AGENDA SECTION: PUBLIC HEARINGS – Continued Item	ORIGINATING DEPT: PLANNING	ITEM NO. E-1
ITEM DESCRIPTION: Final Plat #99-24 to be known as Essex Estates 5 th Subdivision		PREPARED BY: Brent Svenby, Planner

RE: Final Plat #99-24 to be known as Essex Estates 5th Subdivision.

RE: **ESSEX ESTATES FIFTH
FINAL PLAT #99-24**

ESSEX ESTATES FIFTH SUBDIVISION

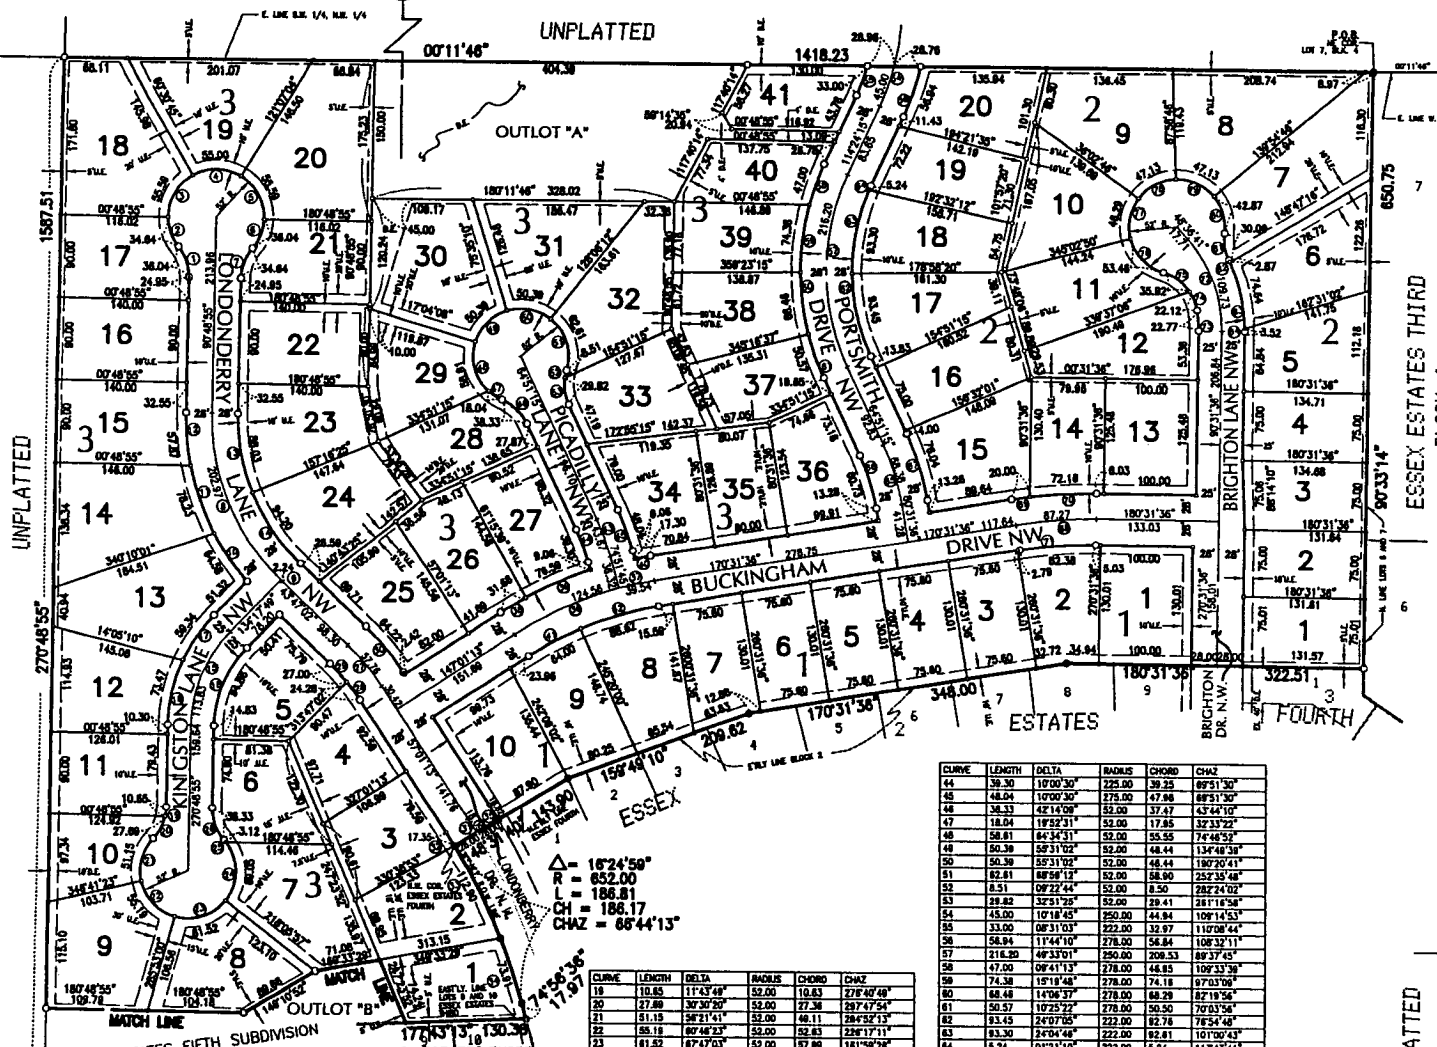
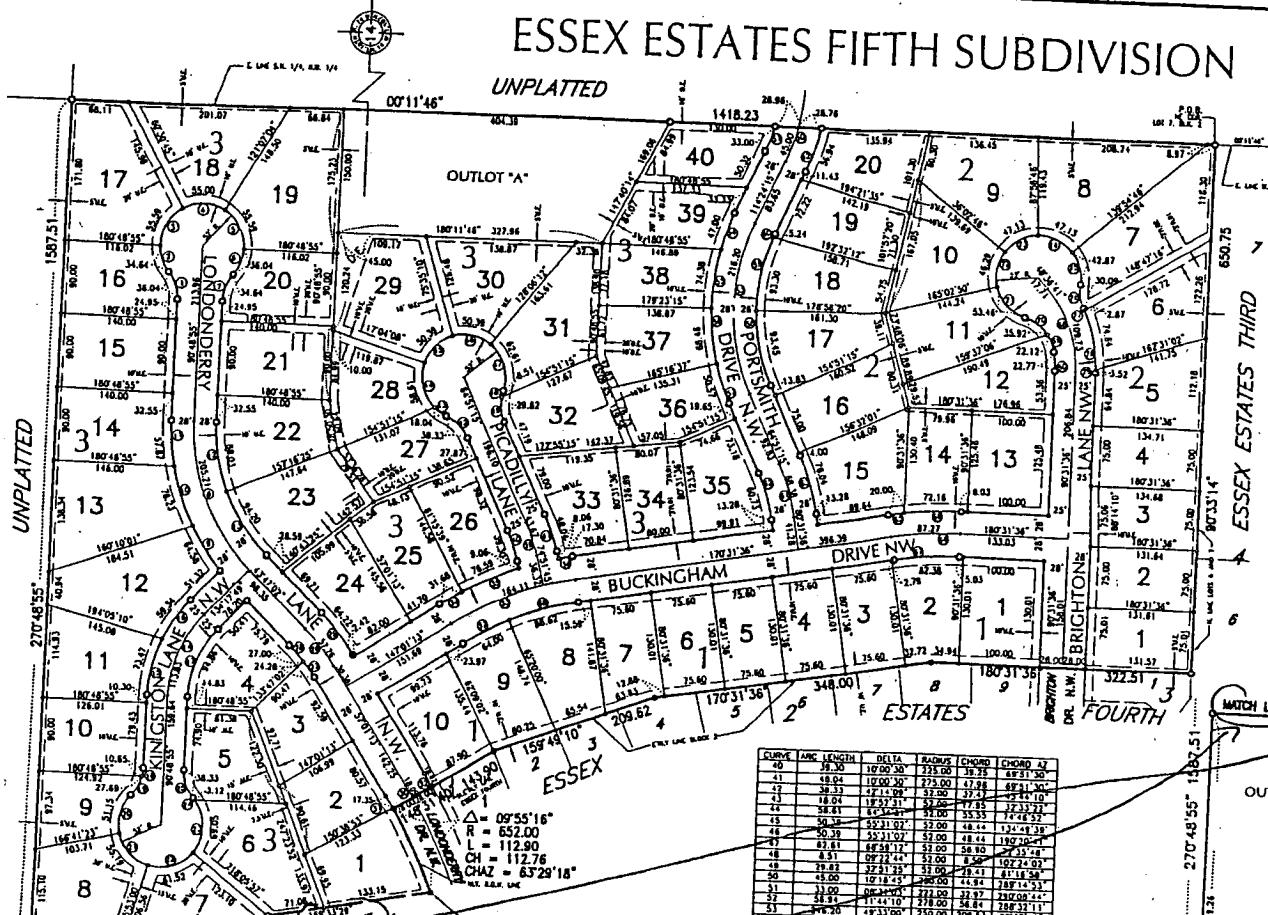
The Planning Staff has reviewed the submitted final plat and finds that it is generally consistent with the approved preliminary plat and previously approved final plat with the exception of Outlot B not having frontage on Londonderry Drive NE. The staff would then recommend approval subject to the following conditions:

1. The roadway named KINGSTON LANE NW is in conflict with the roadway KINSTON PLACE NW found in Kingsbury Hills Subdivision.

The GDP indicates that Outlot B should extend to Londonberry Drive. There should be a minimum 30' access of Outlot B to Londonberry Drive. This dedicated access to provide pedestrian / trail access to Essex Park as well as maintenance access to the stormwater ponds to be located on Outlot B. Public access to Essex Park cannot occur on the 30' UE as shown.

- 3. Prior to recording of the Plat the Owner shall provide to the City a meets and bounds legal description for a 30 foot wide drainage, access, and pedestrian trail easement connection between Londonberry Drive NW and Outlot B. The City will prepare and record the drainage, access, and pedestrian trail easement document. Owner shall pay \$70.03 for the preparation and recording of the easement document. The Owner shall include on the Final Plat the description and document number of the 30 foot wide drainage, access, and pedestrian trail easement.**

- 5. The roadway named Kingston Lane NW shall be renamed with a name approved by the GIS/Addressing Staff. The proposed named Kingston Lane is in conflict with the roadway named Kinston Place NW found in Kingsbury Hills Subdivision.**

RECOMMENDATION: Rename the roadway, but keep the roadway type Lane and the directional of NW.
